PLANNING COMMISSION AGENDA
Monday – February 26, 2007
7:00 PM - Regular Meeting
City Council Chambers - 155 NW 2nd Avenue

TO: *Planning Commission*
FROM: *Matilda Deas, AICP, Project Planner*
DATE: *February 16, 2007*
RE: *N. Baker Drive*

To: Canby Planning Commission;
From: Kevin C. Cook, Associate Planner
Date: 2/15/2007
Re: Larios Project – 1410 S Township Road

Revised Tree Plan for
Knott Commons

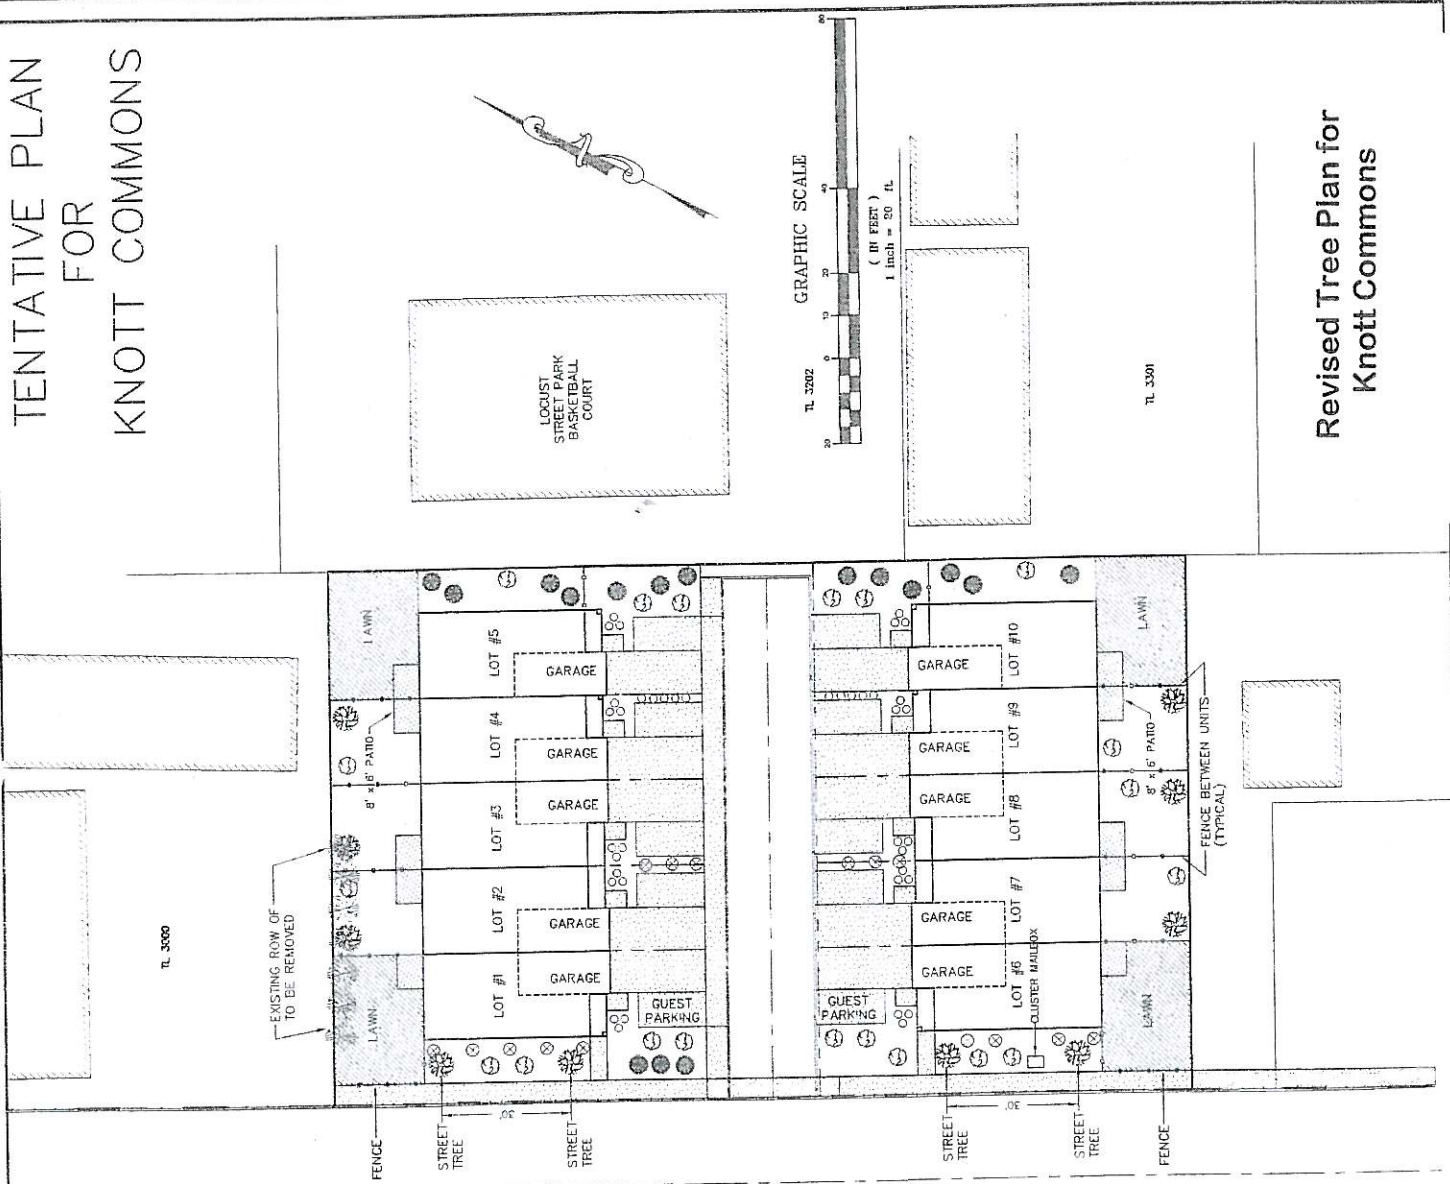
Tree Plan for DR 06-11 – Knott Commons

SITE PLAN

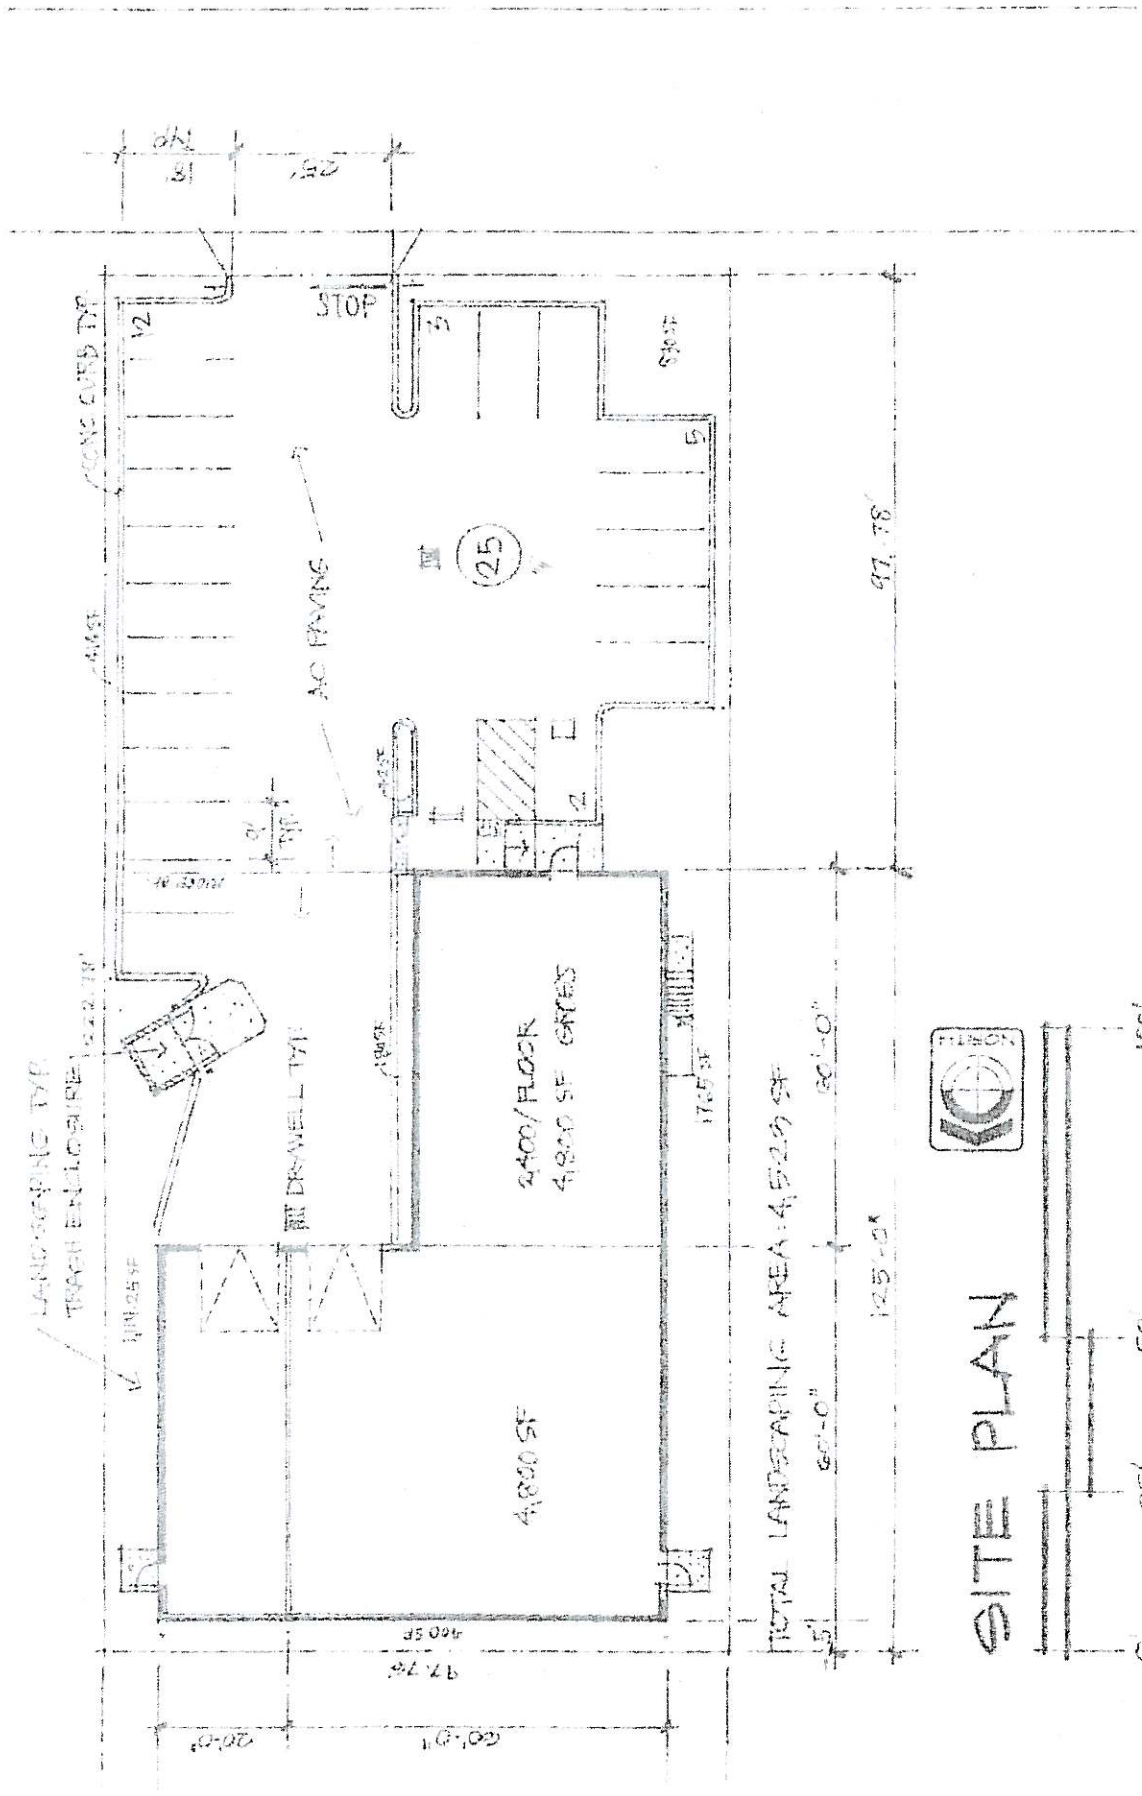
We have received a revised site plan for the proposed Larios Building. The new plan shows a reduced building size of 9,600 sq. ft. (10,200 previously proposed). The proposed floor area consists of 4,800 sq. ft. of office space and 4,800 sq. ft. of warehouse space.

The parking requirement is for 22 parking stalls, which is what the applicant is now proposing on the revised plan.

A trash enclosure has been added to the site plan west of the parking area. The paved area is approximately 10,056 sq. ft. and the proposed landscaping is 4,523 sq. ft. (45%). Two drywells are shown on site.

It is recommended that all conditions of approval from the original staff report remain with the exception of condition 5. Staff will require detail sheets of the lighting plan, landscaping, and stormwater to be submitted with the construction plans at the time of pre-construction meeting.

CANBY COMMERCIAL
1410 S. TOWNSHIP ROAD, CANBY, OR 97103
ELEVATIONS

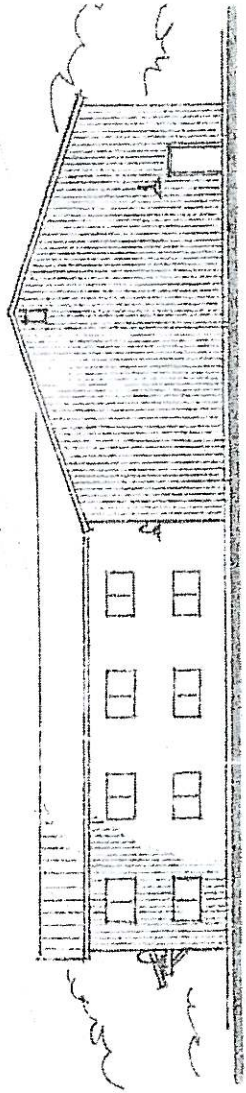
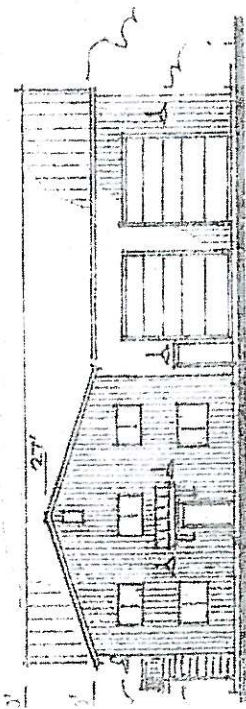
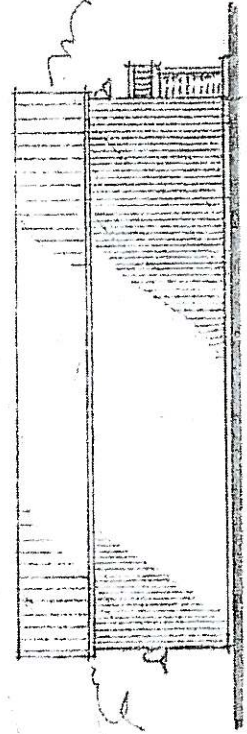
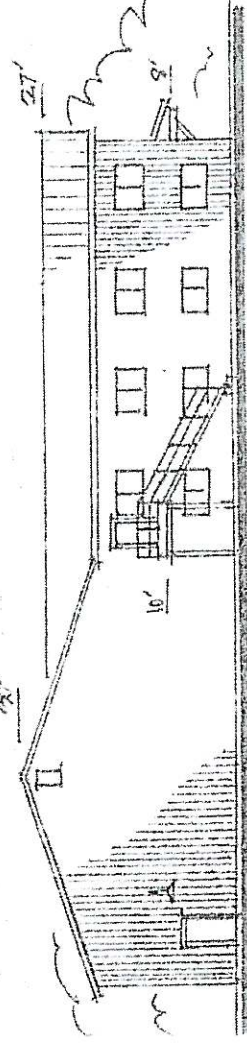
Building elevations show a basic corrugated metal building. Staff believes that although the proposed building is very basic it is, nevertheless, compatible with existing development in the area.
